SHERWARD G. FARNSWORTH, P.E.
Project Manager - Structures Section
VERMONT AGENCY OF TRANSPORTATION
National Life Building - Drawer 33
MONTPELIER, VERMONT 05633-6001
Telephone (802) 828-3874 Fax (802) 828-3566

LETTER OF TRANSMITTAL

DATE: 2-13-2002
CONTRACT No.
PROJECT Name: SR BURLINGTON
PROJECT NO: IM 0209(36)

SUBJECT: Semi-Final Plans - South Burlington IM DECK(36) I-89, Exit 14
Relocation of Verizon conduit's and future relocation of Aldelphia's conduits from Williston Road bridge over I-89 >>>> Duct Bank Relocation <<<<

PLAN VIEW - EXPANSION JOINT
(PIER 1 - WESTBOUND)

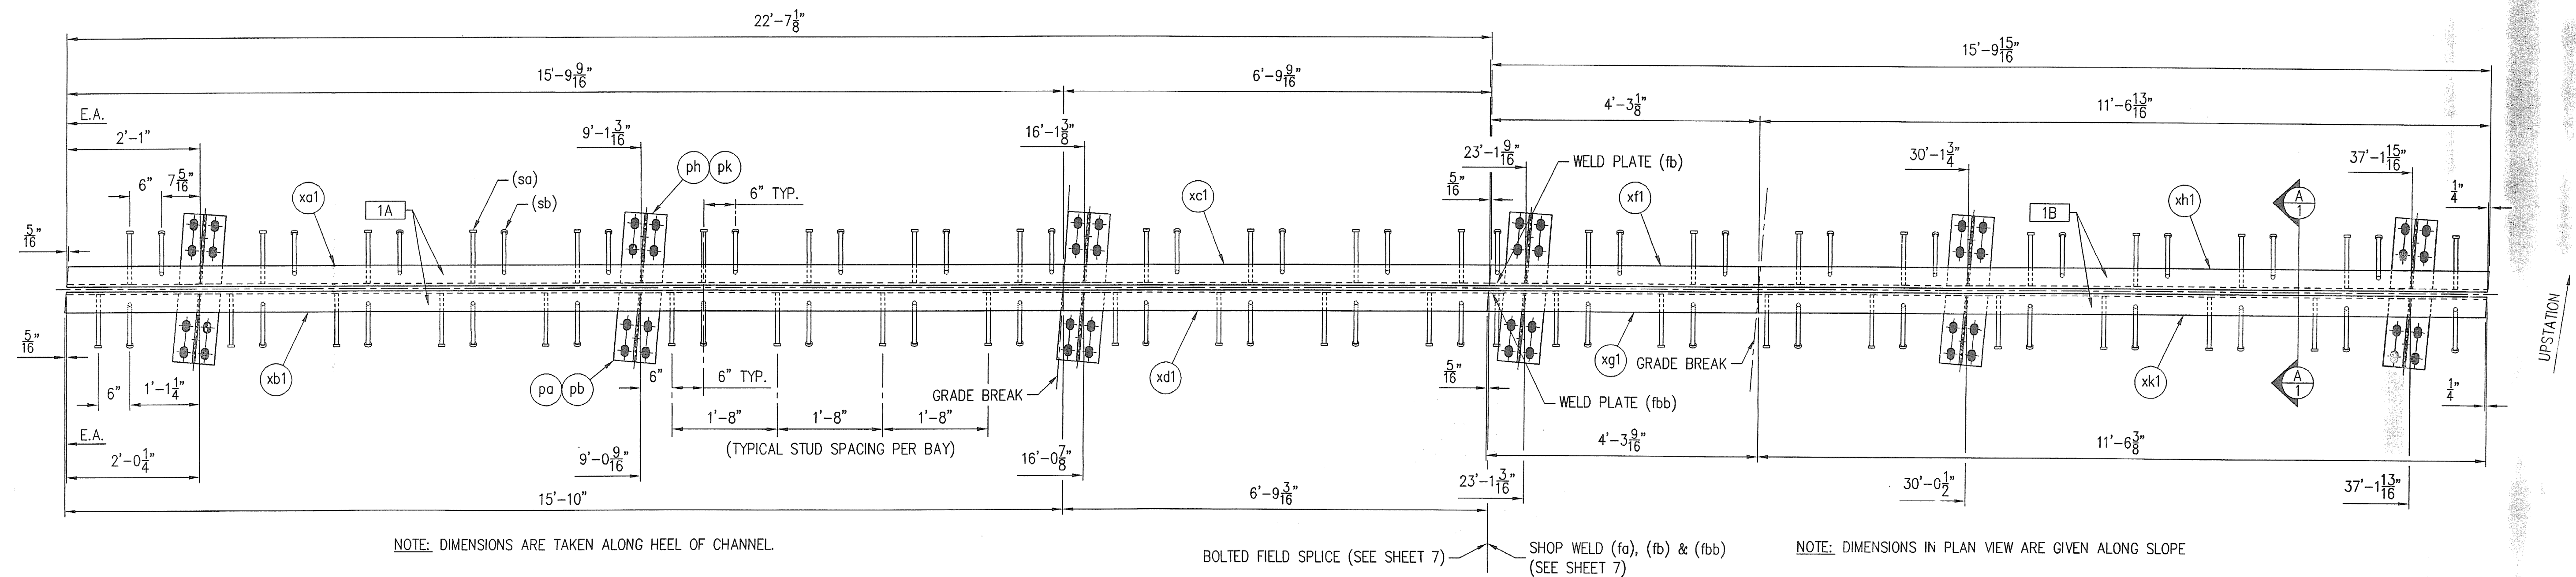
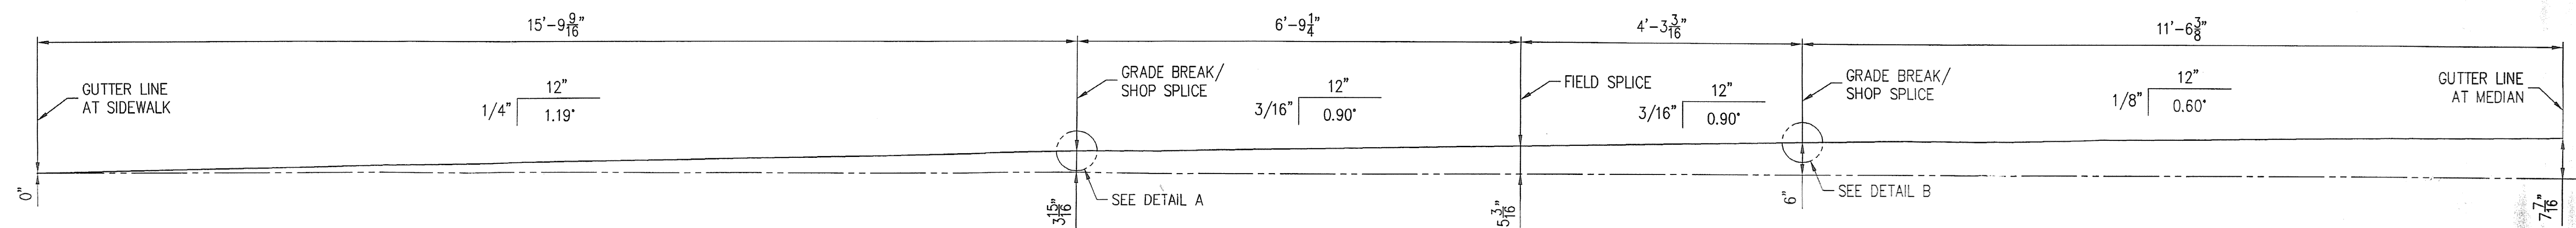
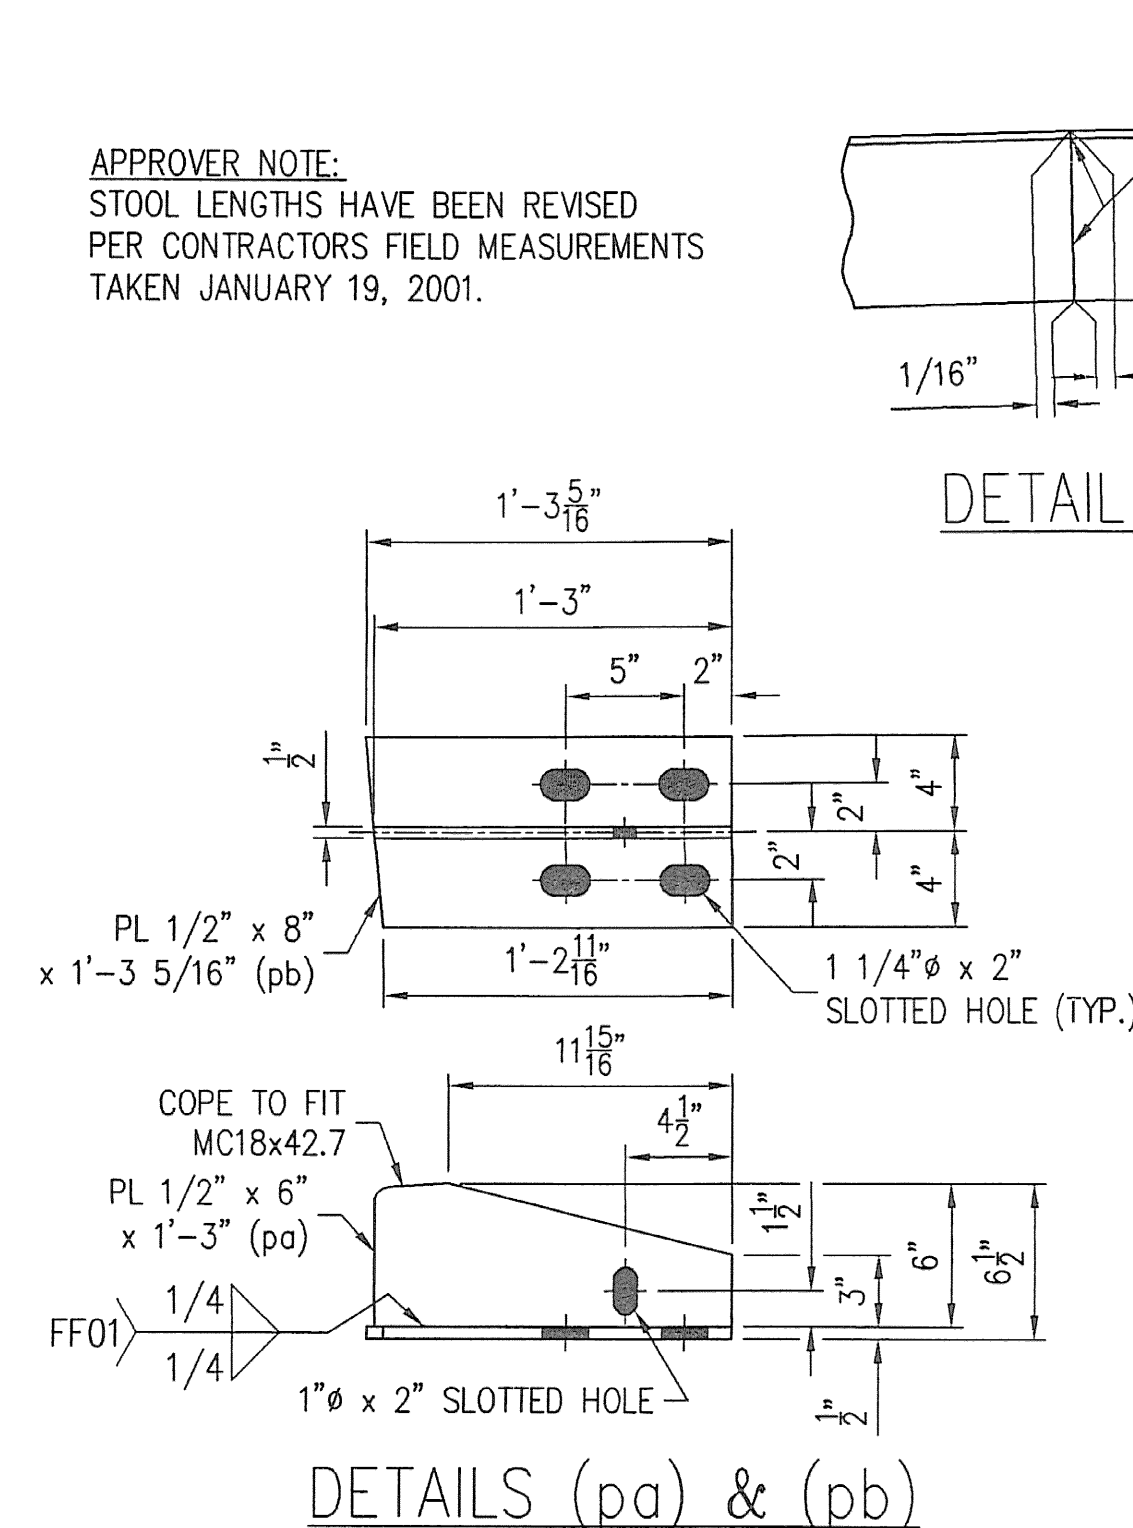
APPROVER NOTE:
STOOL LENGTHS HAVE BEEN REVISED PER CONTRACTORS FIELD MEASUREMENTS TAKEN JANUARY 19, 2001.

PLAN VIEW - EXPANSION JOINT
(PIER 1 - EASTBOUND)

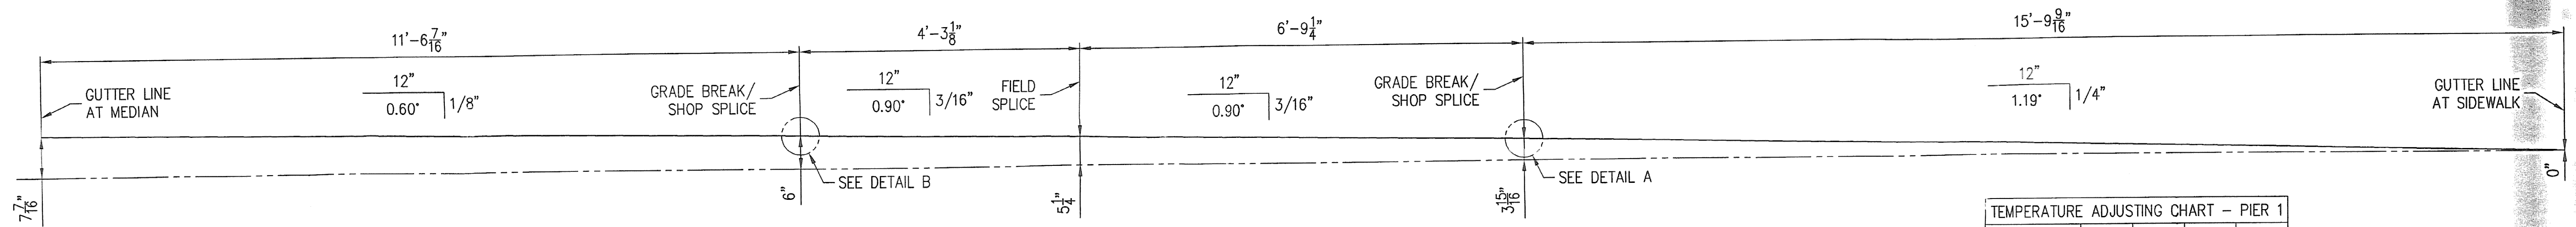
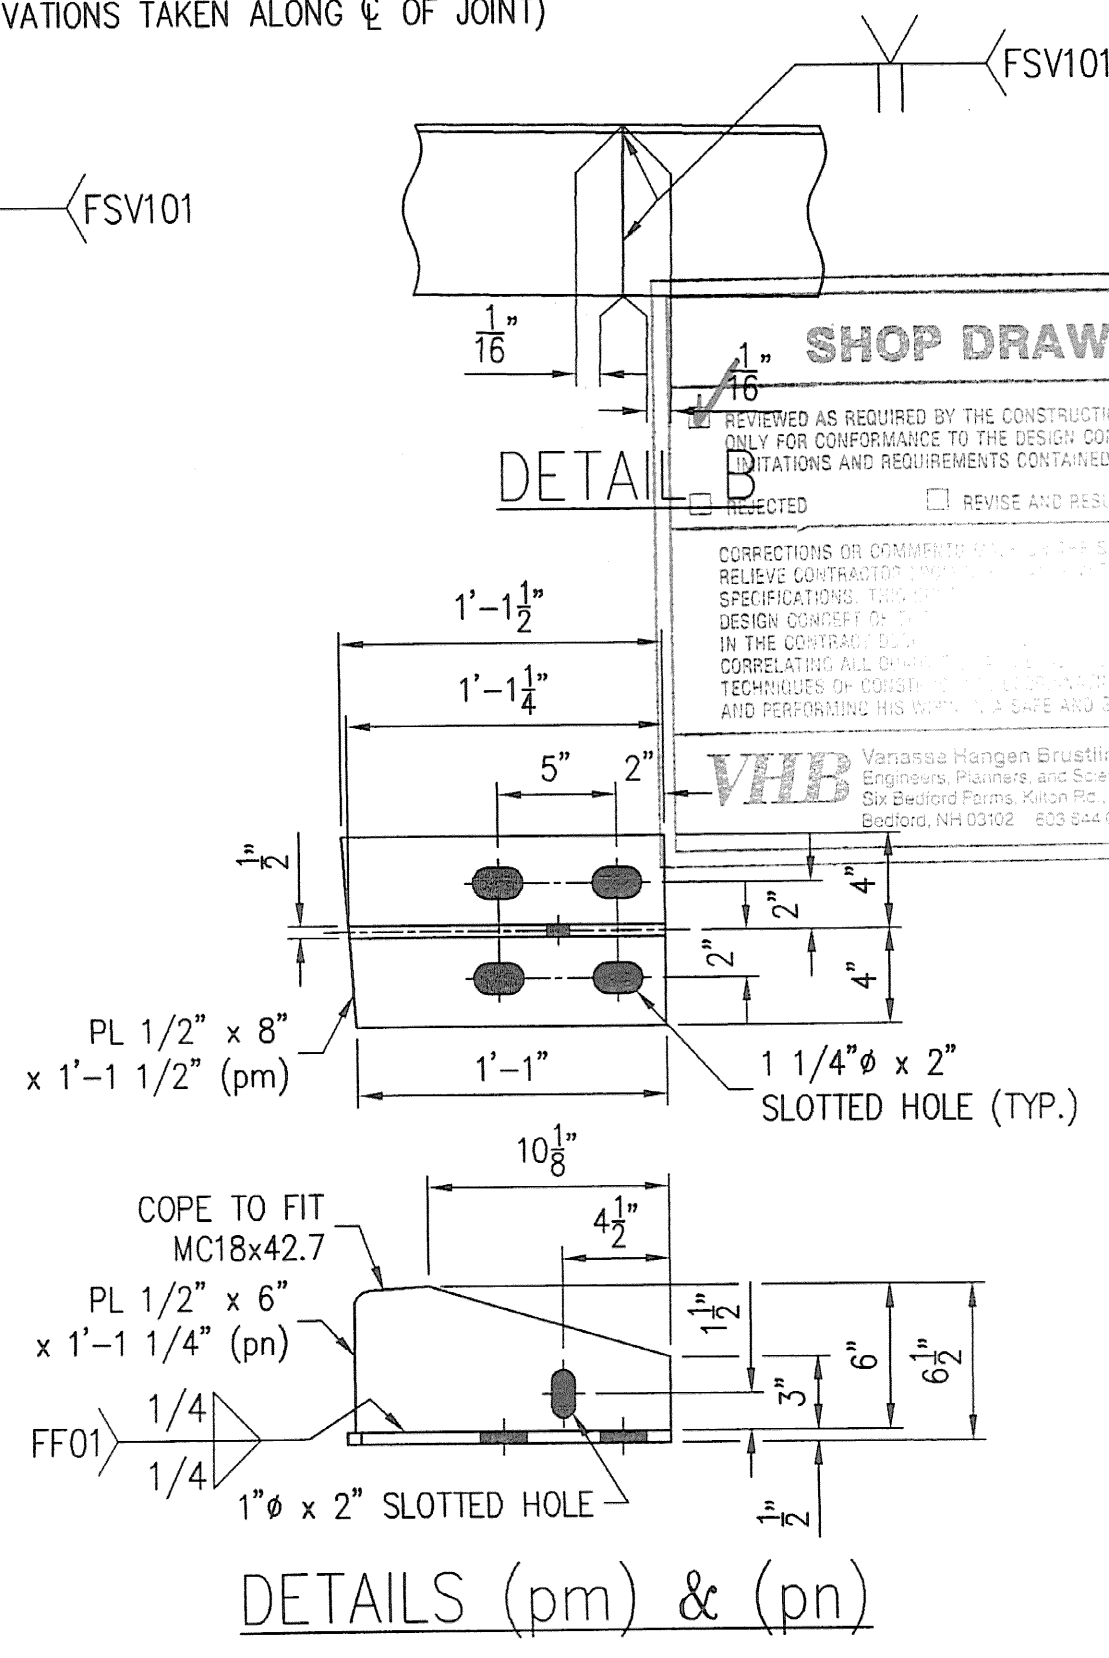
APPROVER NOTE:
STOOL LENGTHS HAVE BEEN REVISED PER CONTRACTORS FIELD MEASUREMENTS TAKEN JANUARY 19, 2001.

ELEVATION - NORTH BRIDGE RAILING FACING NORTH
SOUTH BRIDGE RAILING SIMILAR
TOTAL PAY LIMIT ITEM 525.34(BRIDGE RAILING - 4 RAIL) = 550 LF

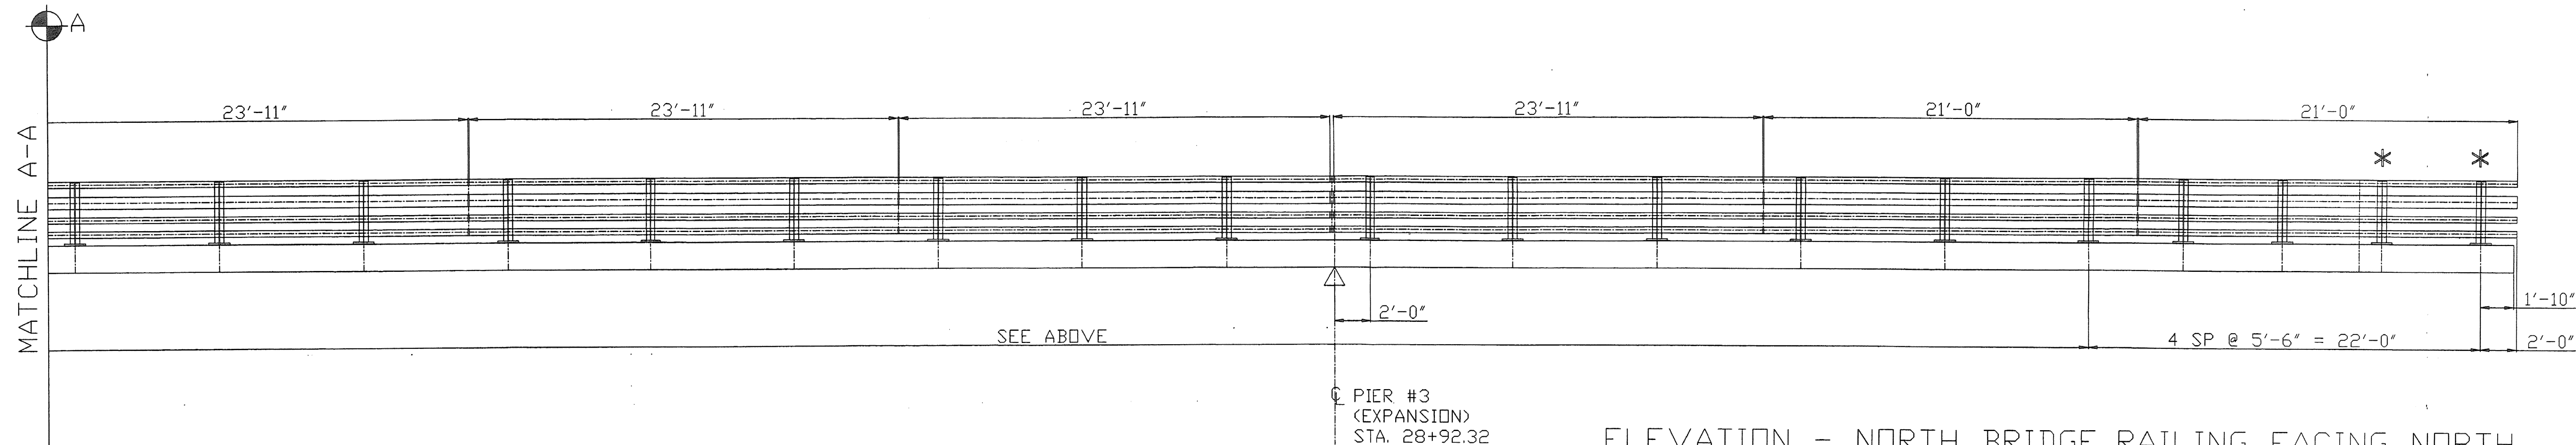
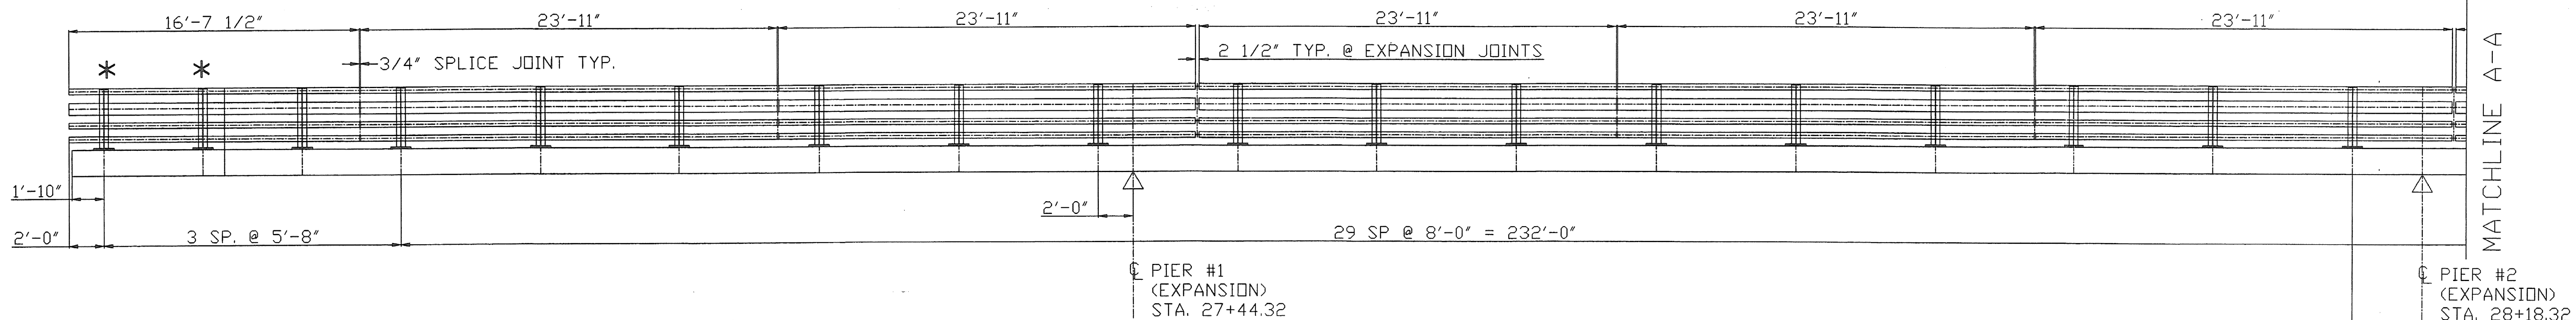
△ * - DENOTES SPECIAL WING WALL POST SEE SECTION "N" PAGE 2/2
VERIFIED BY FIELD MEASUREMENTS 9/25/00
